UNITED STATES PATENT AND TRADEMARK OFFICE

APPLICATION NO.	FILING DATE	FIRST NAMED INVENTOR	ATTORNEY DOCKET NO.	CONFIRMATION NO.
09/739,975	12/20/2000	Rieko Fukushima	02887.0199	3736

Office Action Summary

FIG. 1

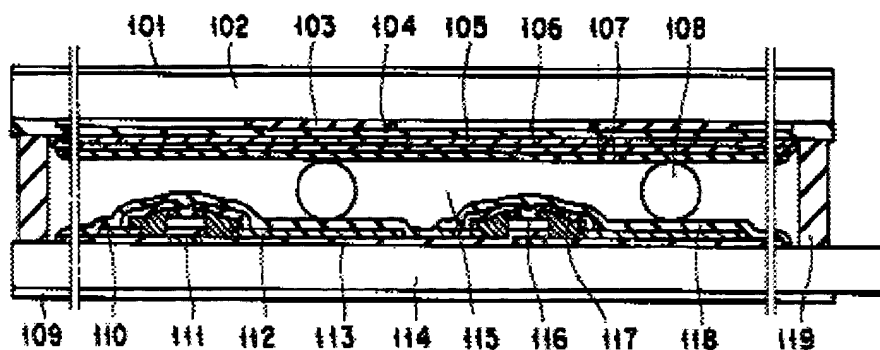
As to claim 8, Saishu discloses in Figure 1 (col. 6, line 60 through col. 8, line 45), a liquid crystal display element comprising: a first substrate, 114; a switching element disposed on said first substrate; a second substrate, 102, counter to said first substrate; a first alignment layer formed over said switching element, 118; a second alignment layer, 107, formed over said second substrate, wherein said first and second alignment layers are rubbed in rubbing directions (col. 7, lines 35-40); a light modulating layer, 115, disposed between said first and second substrates wherein the light modulating layer comprises an anti-ferroelectric liquid crystal material having a thresholdless voltage-transmittance characteristic (col. 7, lines 43-45); and a filter, 104, formed on said second substrate, wherein said filter allows specific wavelengths of light to pass.

Saishu does not explicitly disclose an element wherein the surface tension of each of said first and second alignment layers is between about 49 dyn/cm and about 53 dyn/cm.

Nakamura teaches in Example 1 (col. 16, lines 65-69) the use of a surface tension of 50 dyn/cm to establish uniform alignment and improve contrast (col. 17, lines 25-31). Nakamura also teaches in Example 9 (col. 20, lines 64-67) the use of a surface tension of 49 dyn/cm to establish uniform alignment and improve contrast.

Nakamura is evidence that ordinary workers in the art of liquid crystals would find the reason, suggestion, or motivation to add alignment layers having surface tension in the range of 49 dyn/cm to 50 dyn/cm (overlaps Applicant's range of 49 dyn/cm to 53 dyn/cm) to establish uniform alignment and improve contrast.
